SUBJECT: FORT CALHOUN STATION, UNIT NO. 1 - 2005 STEAM GENERATOR  
INSPECTION CONFERENCE CALL SUMMARY (TAC NO. MC5776)

**MARCH 14, 2005 CONFERENCE CALL SUMMARY**

**2005 STEAM GENERATOR TUBE INSPECTIONS**

**FORT CALHOUN STATION, UNIT 1**

Figure 1  
Eggcrate and Tube Support Plate Intersection – Top View

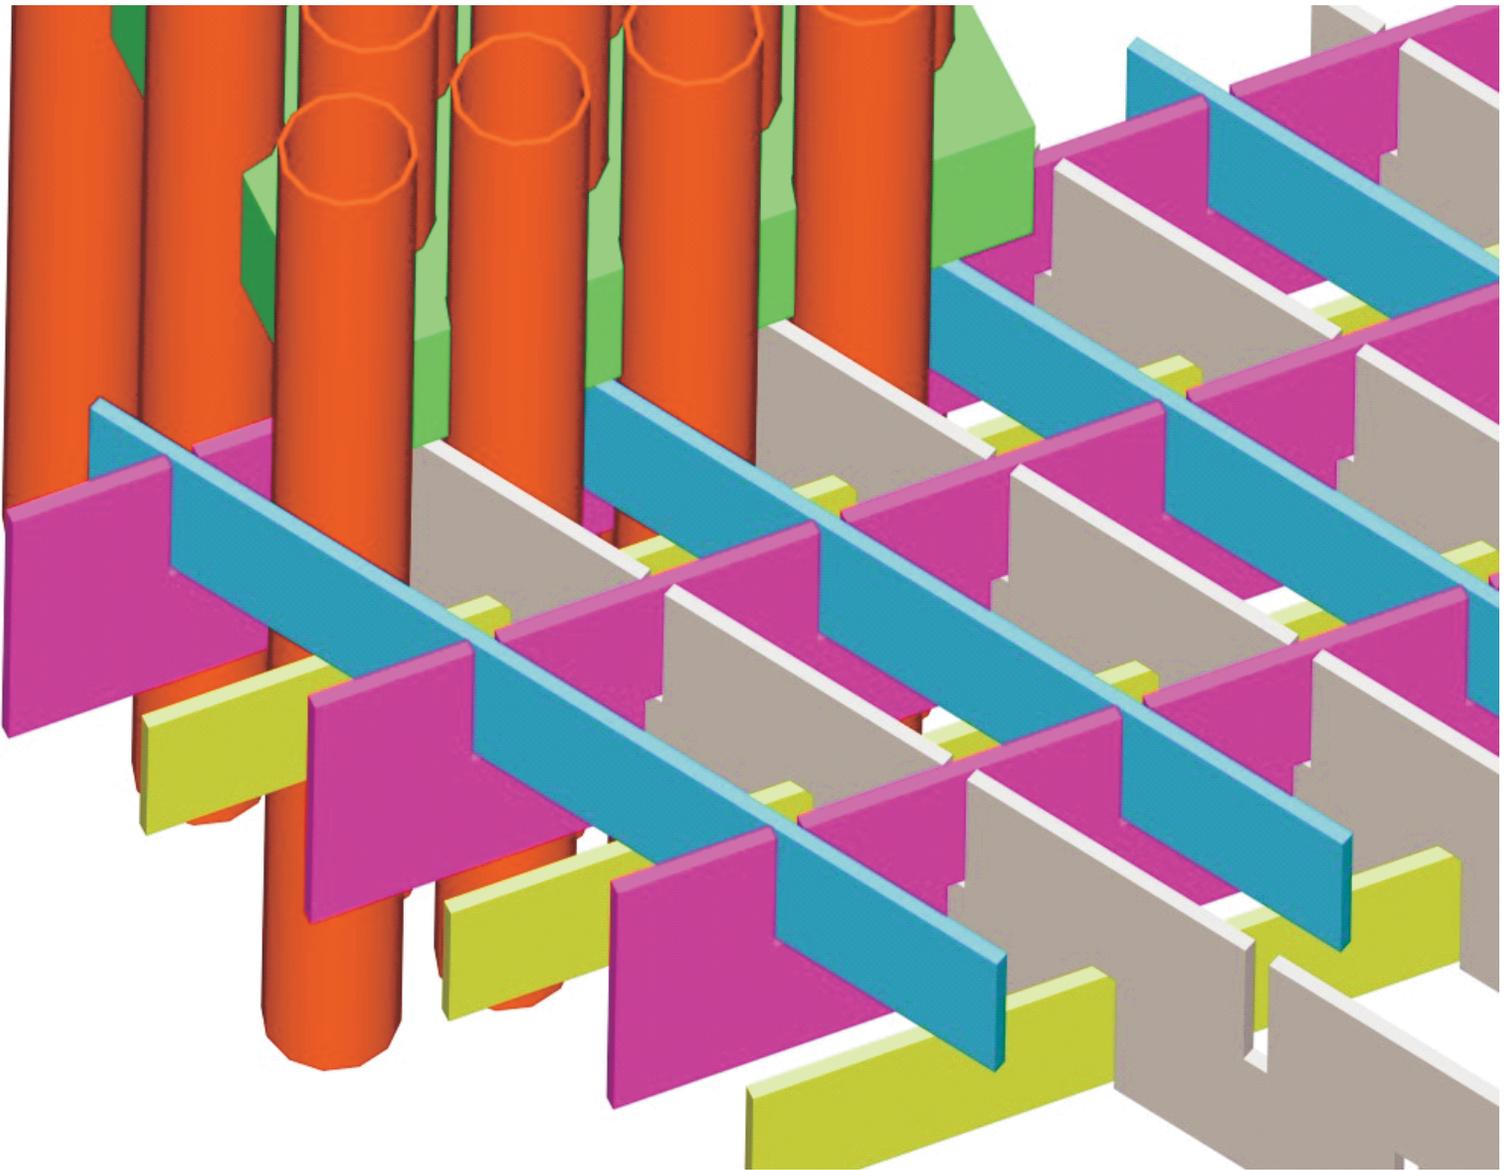
The area defined as the "Circumferential Critical Area +2 to -6 inches", is the area where the drilled hole portion of a support (i.e., the patch plate) meets the eggcrate portion of the support. In this region, two lines of tubes are supported by both supports (eggcrate and drilled hole). The drilled support plate is positioned directly above the eggcrate support. The edge of the drilled plate is scalloped, having the shape of a series of semi-circles when viewed from above. One of the lines of tubes is in contact with the scalloped edge of the drilled support plate (i.e. it is only supported on one side by the drilled hole support) and is fully supported by the eggcrate support directly below it. The other line of tubes is fully supported by the drilled support and is only supported on one side by the eggcrate support directly below the drilled plate. Growth of the drilled plate from denting could result in a bending strain at and below the eggcrate where the tube is restrained by movement in the lateral plane. This area is inspected 100 percent with a rotating probe from 2 inches above the supports to 6 inches below to identify any cracks that may occur in the freespan as a result of strain caused by the interaction of

the supports. Figures depicting the Circumferential Critical Area were supplied by the licensee and are attached to this summary.
